Model: V-C2/MT-C4 Finisher(SR4010/4020/4030/4040)

No.: RD373002

Subject: SHIELDING PLATE: RIGHT: UPPER

Subject: Stapler Tray

Frame Section (D373/D374)

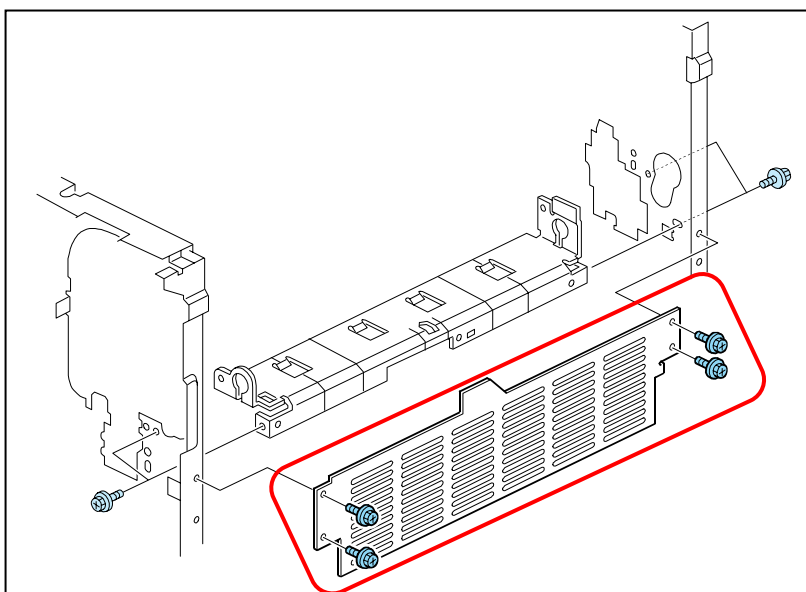
Change: The following part framed in red is added for the following reason.

Reason: To further protect the inside of the SR4010/4020/4030/4040 from being touched.

Note: There is small possibility of the above case, so this change isn't applied to the SR4010/4020/4030/4040 units which have already been installed in the field.

[Stapler Tray (Pg.23 Index#17)]

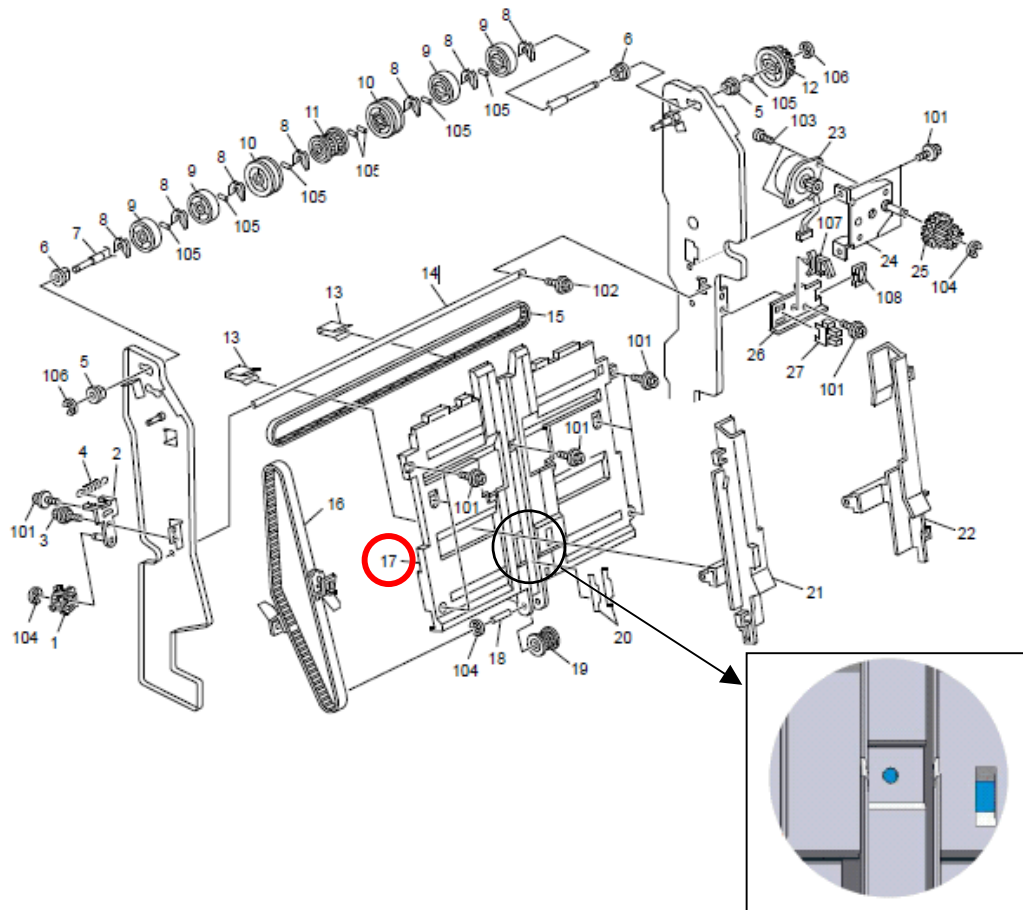
Change: A tapping screw was added for attaching the stapler tray to the lower stay positioning sensor, and screw holes were added as shown below.

Reason: To further improve structural reliability.

Stapler Tray

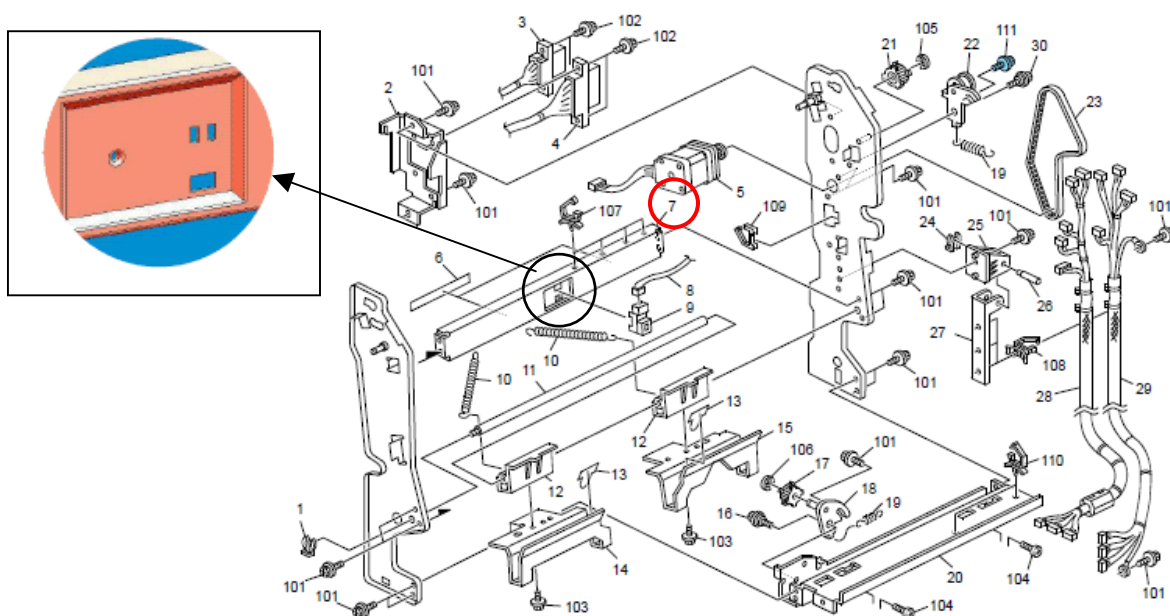
Change: A tapping screw was added for attaching the stapler tray to the lower stay positioning sensor, and screw holes were added as shown below.

Reason: ***To ensure that Jam Code 194 does not occur due to deformation of the stapler tray.***

Stay: Lower: Positioning Sensor

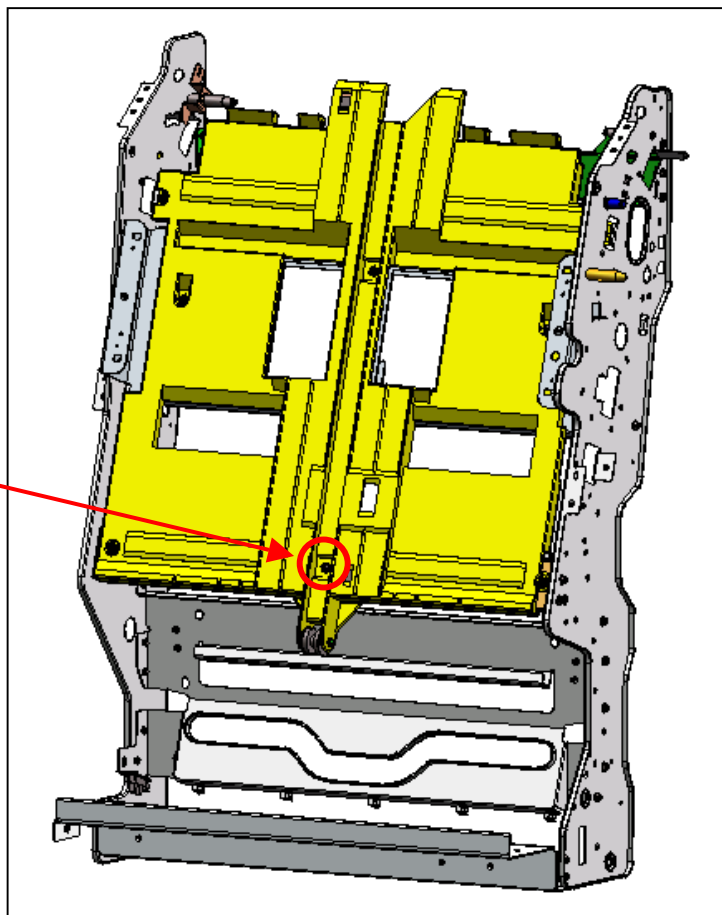
*Use the M3x6
tapping screw here.*

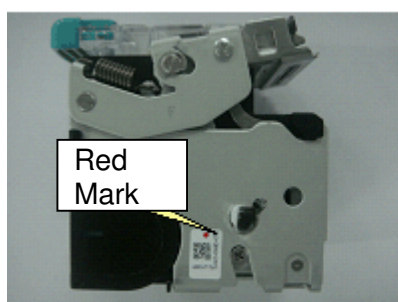
Important: Stapler units on some of these affected finishers have already been replaced with the normal ones. If there is a **red dot** on the stapler unit's label (see the photo below), you **do not need to replace** these units.

Replace the stapler unit.

The affected stapler unit is shown in the illustration below (Index #24):

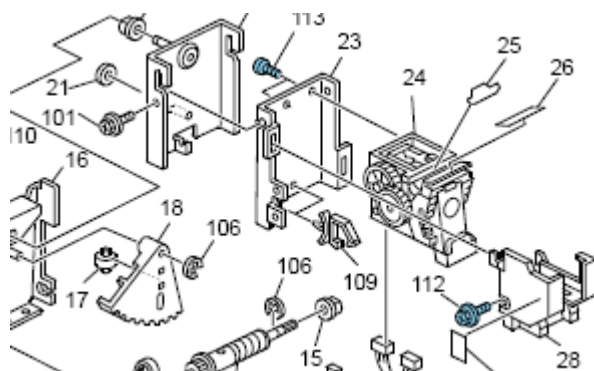
1. These parts contain staplers and Mylars but not cartridges.
2. Stapler units for corner stapling on the affected finishers with the parts that were registered specifically for this issue (also listed below). So, this issue does not apply to booklet stapler units (B7007852), so you do not need to replace these.

Replace the affected stapler units with the following part numbers for the intended models

Subject: Gate pawl proof tray damage

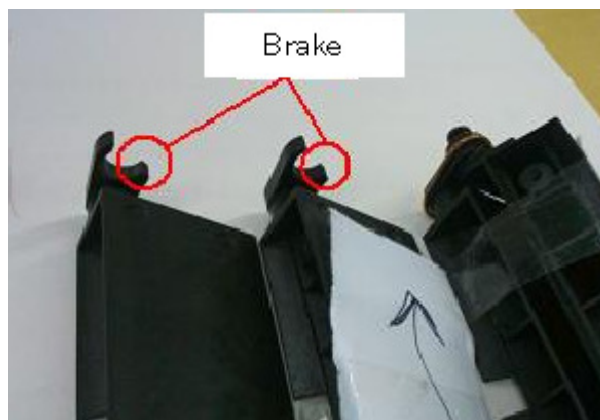
The gate pawl on the proof tray breaks.

The part was assembled incorrectly.

Assemble the part in the correct way, as shown in the procedure below.

1. Hook part **[A]** on the upper plate ["(2)"] onto the area shown on the plate (1).
2. Attach part **[B]** on the upper plate to area **[B]** on the lower plate ["(1)"], as shown in the close-up.
3. Attach part **[C]** on the upper plate to area **[C]** on the lower plate in the same way as in Step 2.
